# Municipal Corp. of Cape Charles

## Memo

RE: ADU/STR occupancy considerations

537 JEFFERSON AVENUE #1

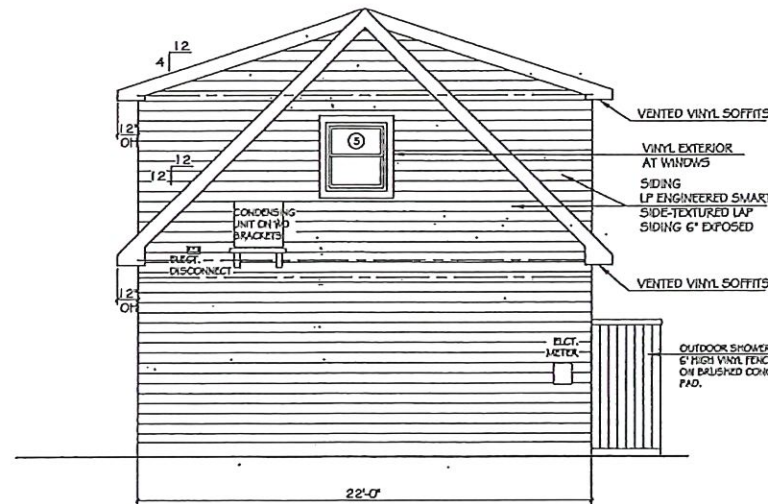
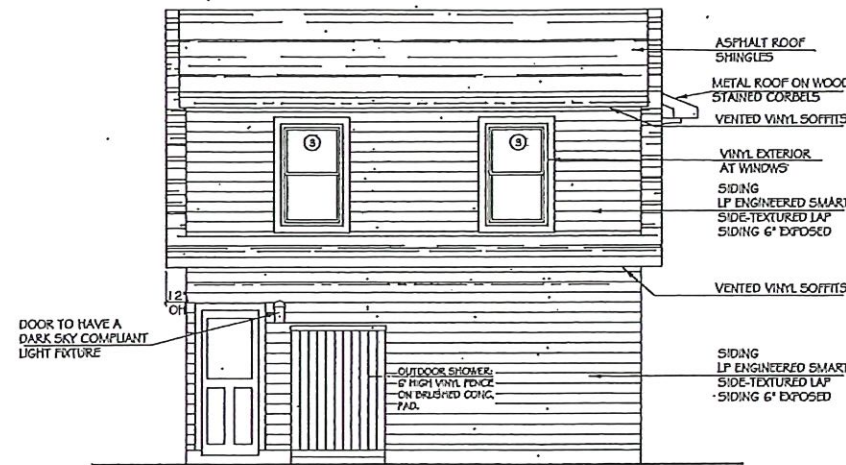
Example 1 is a 440 square foot unit comprised of a kitchen/dining, living/sleeping area and a 40 square foot bathroom. While you ponder the allowance of the plus 2 I would like for you to consider how this will be enforceable from a code standpoint. As the Building Code/Zoning Ordinance reads a minimum of 50 square foot space per occupant in the bedroom area is required when serving more than 1 person. This creates a real gray area for enforcement purposes in determining what is the measurable sleeping area square footage vs what is the living and kitchen area. What determines the square footage of the sleeping area?

9 Park Row

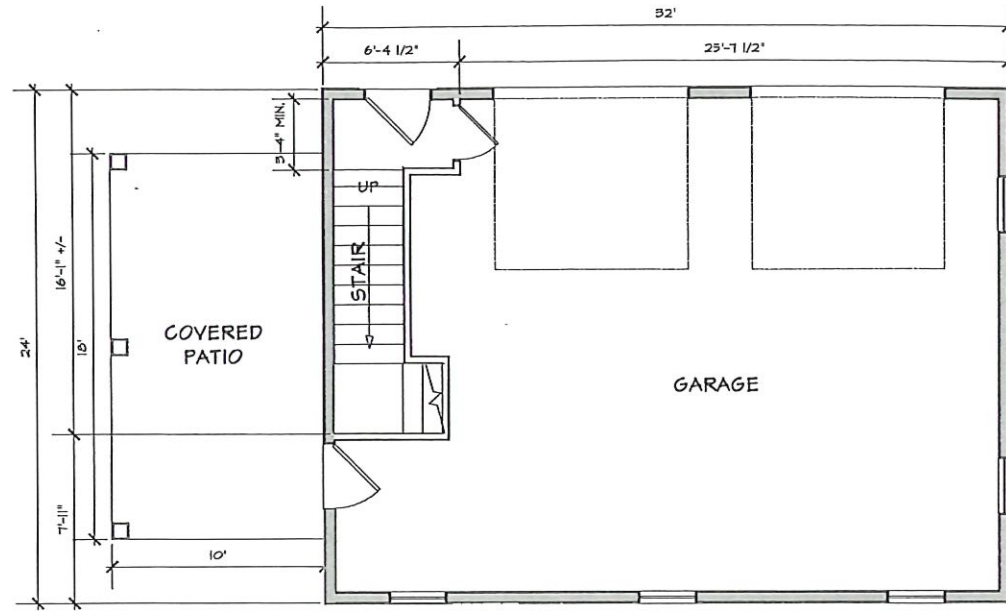
Example 2 is a 336 square foot unit comprised of a living/kitchen area, bathroom, and a 100 square foot bedroom. This example would only allow 2 people as-built due to the square footage of the existing bedroom and per the definition of a bedroom the living area could not be counted as another bedroom.

211 MADISON AVENUE

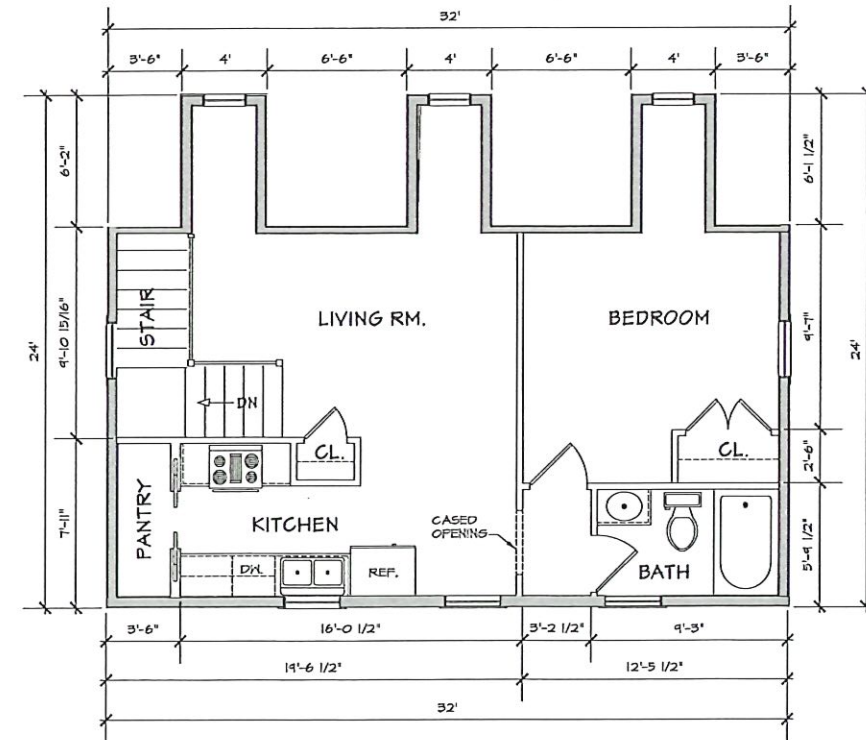
Example 3 is a 576 square foot unit comprised of a living room, kitchen, bathroom, and 144 square foot bedroom. This example would only allow 2 people as built due to the square footage of the existing bedroom and per the definition of a bedroom the living area could not be counted as another bedroom.

500 MONROE AVENUE #4

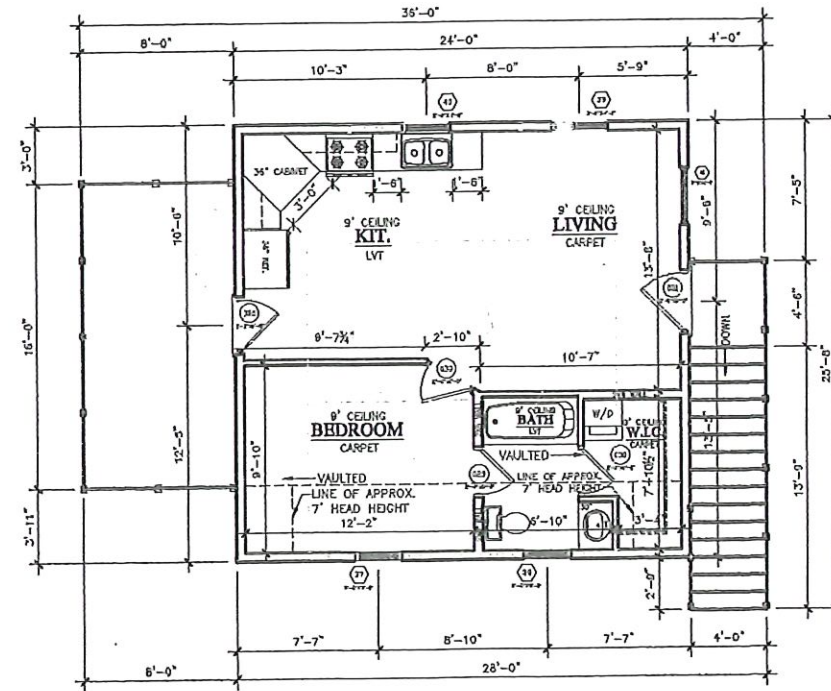
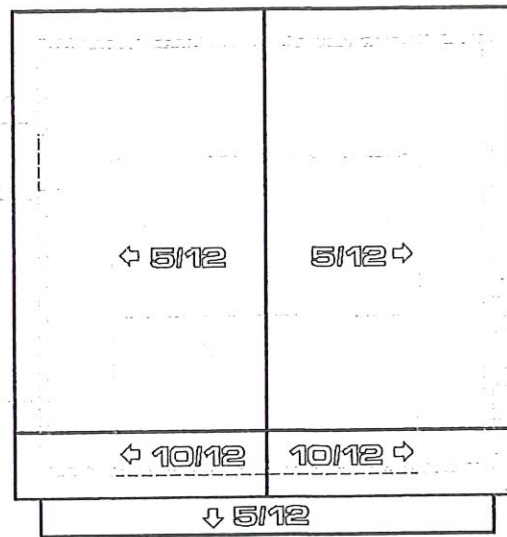
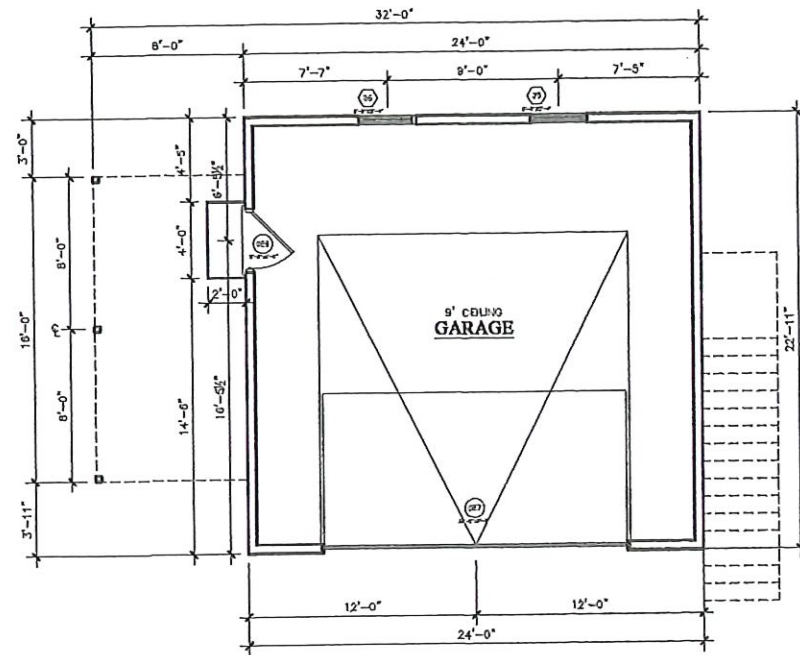
Example 4 is a 432 square foot unit comprised of a living room, kitchen, bathroom, and a 120 square foot bedroom. This example would only allow 2 people as built due to the square footage of the existing bedroom and per the definition of a bedroom the living area could not be counted as another bedroom.
